SERVICE BULLETIN

Classification: EM02-003	Reference: NTB02-050	Date: April 23, 2002
-----------------------------	-------------------------	-------------------------

VQ ENGINE WATER PUMP O-RING

APPLIED VEHICLES: 2002 Pathfinder (R50)
2002 Maxima (A33)
2002 Altima (L31)

Figure 1

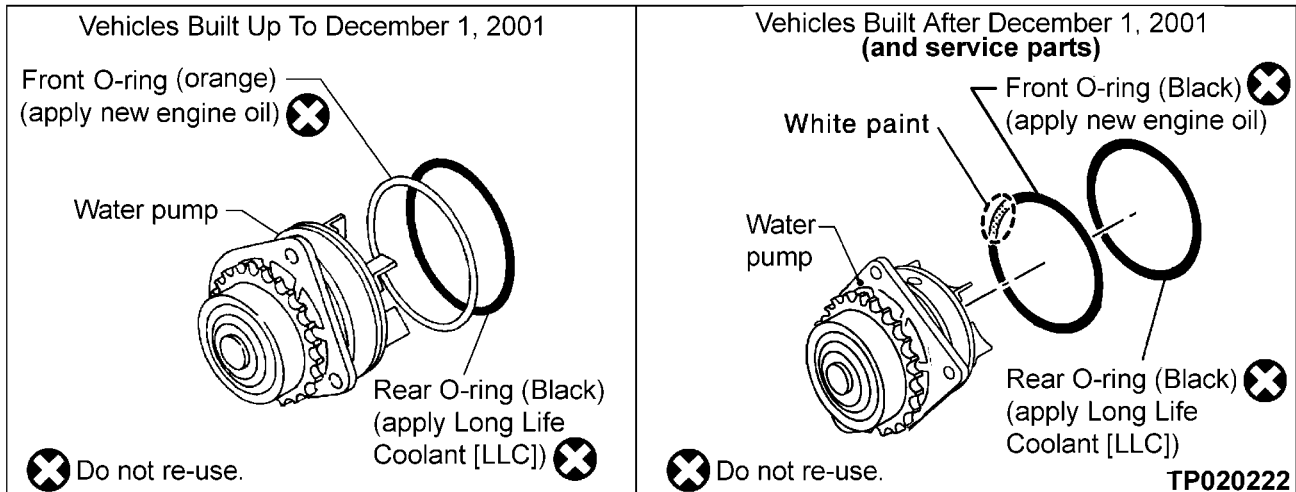
- The front O-ring (on the water pump) has changed
- The new O-ring is now black with a white paint mark instead of orange in color (see Figure 1)
